DUNELAND SCHOOL CORPORATION

2020 NURSE'S OFFICE RENOVATIONS AT: BAILLY ELEMENTARY SCHOOL

TRIA PROJECT#: 20-006

ISSUED FOR PROPOSAL:
APRIL 07, 2020

1 PARTIAL REFLECTED CEILING PLAN
1/4" = 1'-0"

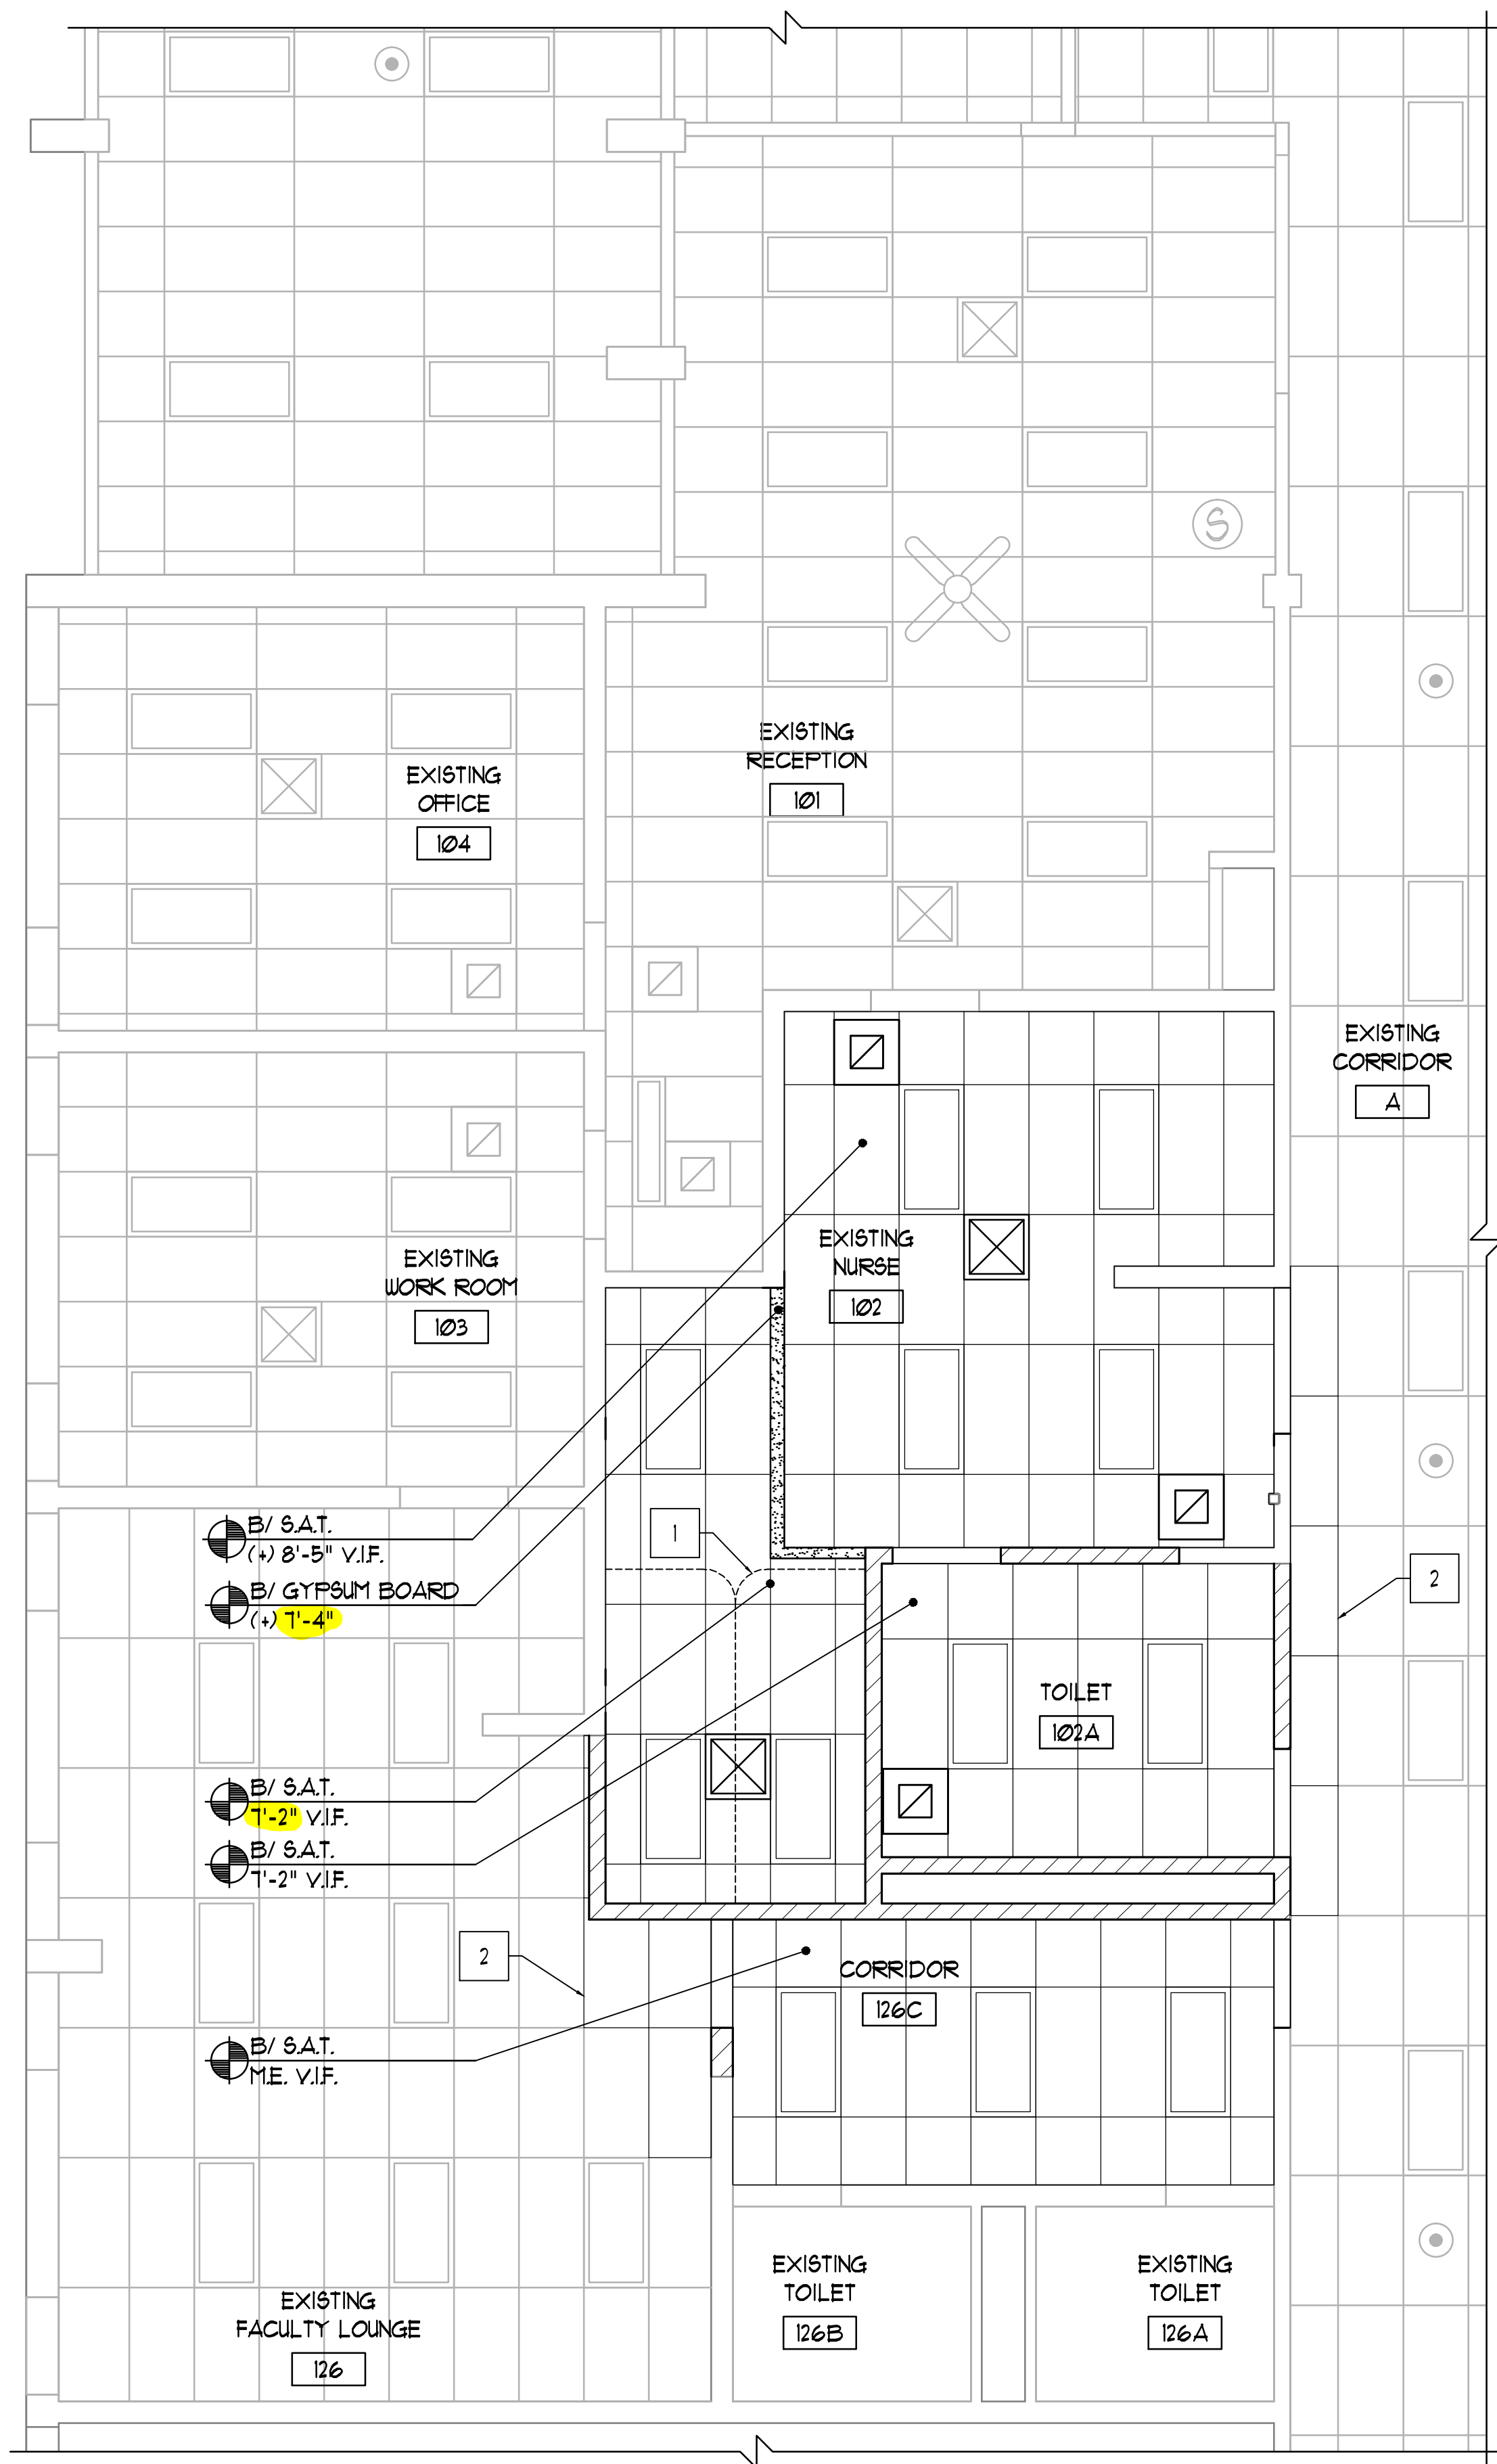
Subject: Acoustical Ceiling Tile

Request: The specification calls for USG Radar Climate Plus 2410. We are hearing from our local supplier that Duneland Schools has been using Certainteed's Fine Fissured HMF-197. Please confirm which ceiling tile you would like.

Response: Certainteed's Fine Fissured HMF - 197 is acceptable. Provide shop drawings for grid and tiles.

1 PARTIAL FLOOR FINISH PLAN
1/4" = 1'-0"

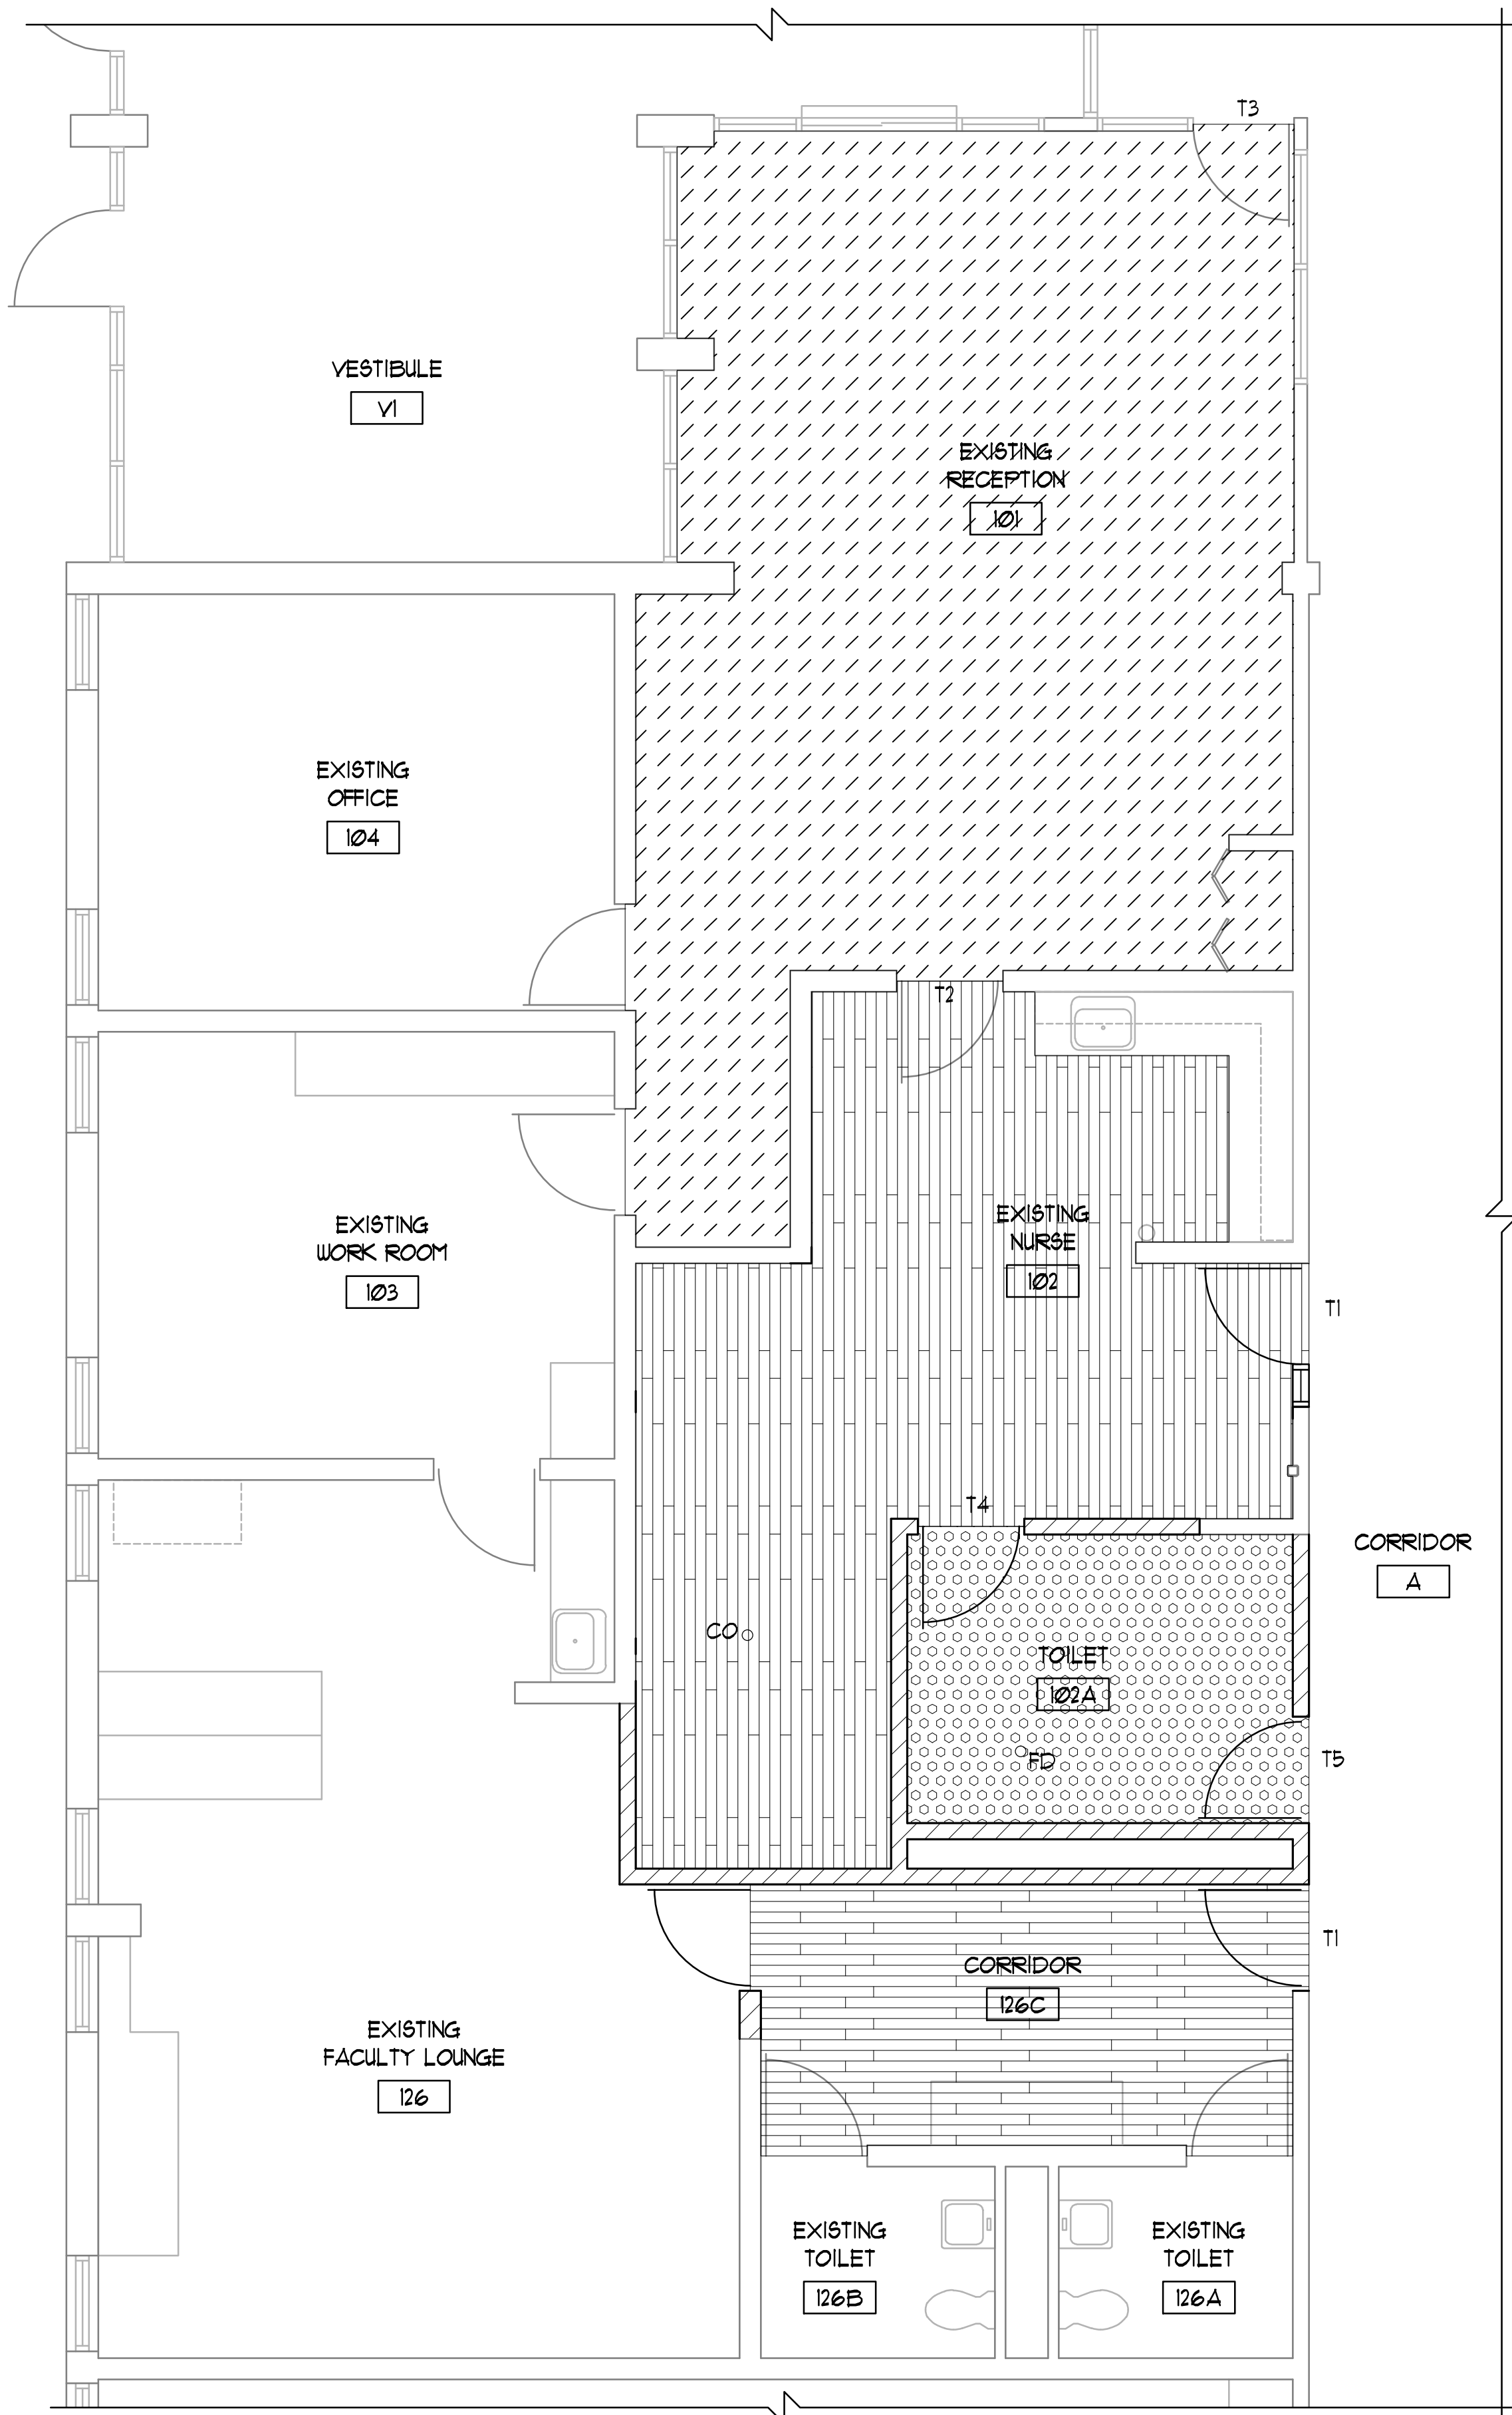
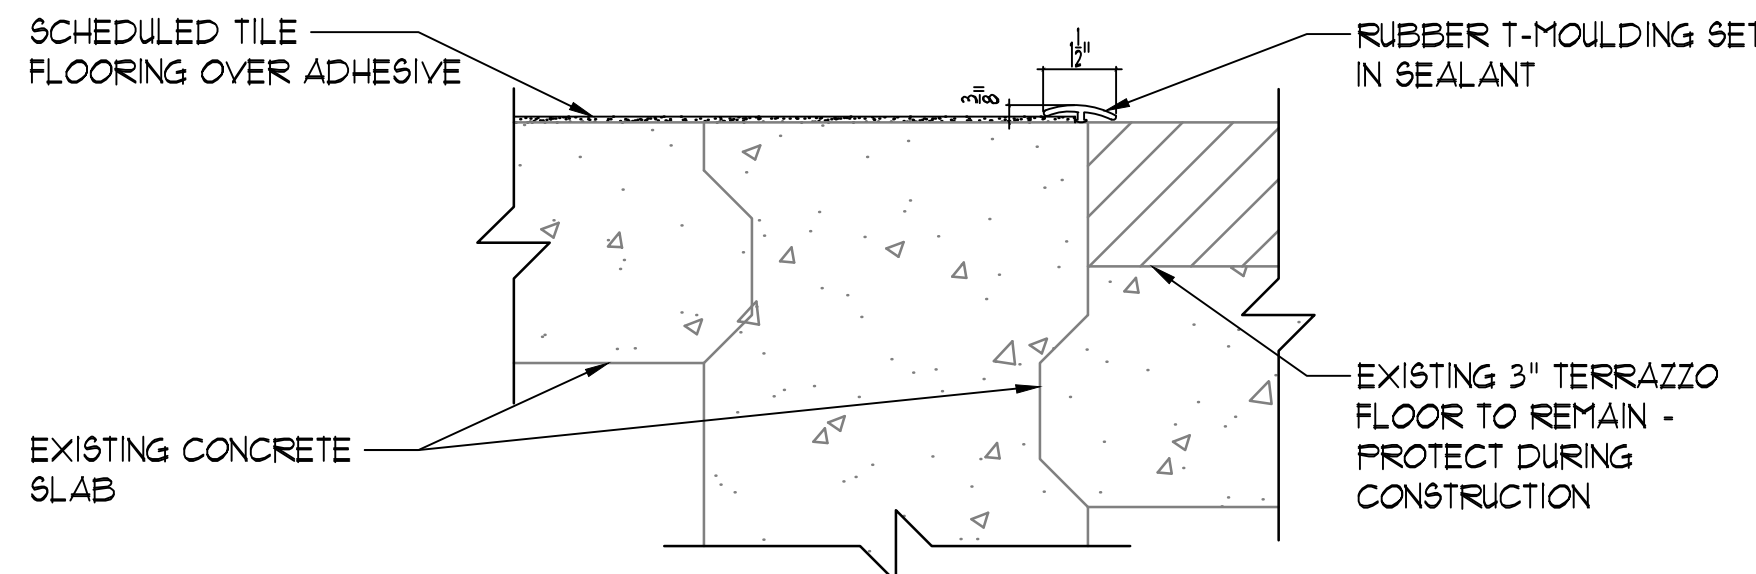
11. QUESTION: What is expected of the terrazzo flooring in the existing reception area and the doorways adjacent to the existing corridor where new flooring is to be installed? Is it to be demoed in its entirety?

12. QUESTION: What would be the expectation with the terrazzo flooring and terrazzo base where the new walls are being built and where the existing walls are being demoed. Please advise.

13. QUESTION: Is the LVT1 & LVT2 a 50/50 random pattern blend? Or do they have a certain pattern they are wanting to use?
ANSWER: Provide LVT-1: Interface, Studio Set #A007, Color A00702 Pewter only at the Existing Nurse 102.

14. QUESTION: Toilet 102A calls for tile on the walls, but there are no drawings or clear instructions. Are they taking this to the ceiling or a certain height off the floor? Also calls for ceramic tile wall base, but not very clear.

ANSWER: Existing Terrazzo (Approximately 6ft x 15ft) to remain at Existing Reception 101. Contractor to prep-existing subfloor for new floor finish as well as level, smooth and feather existing floor to match elevation of terrazzo.

ANSWER: Remove existing floor finish and wall base as required to provide work indicated. Sawcut terrazzo at floor finish transition areas. At removed flooring and walls, patch and prep floor for new floor finish. Infill floor at removed terrazzo to meet existing floor level. At Existing Corridor A only, all new CMU walls should have no wall base. Provide appropriate ADA floor transition strips are every change in floor finish material.

ANSWER: Refer to drawing A3.00 (attached). Per spec section 09300, Floor Tile: 12"x24", Walls: 4"x24". Provide porcelain tile bull nose top trim piece (3"x12") and coved wall base to match specified wall tile.
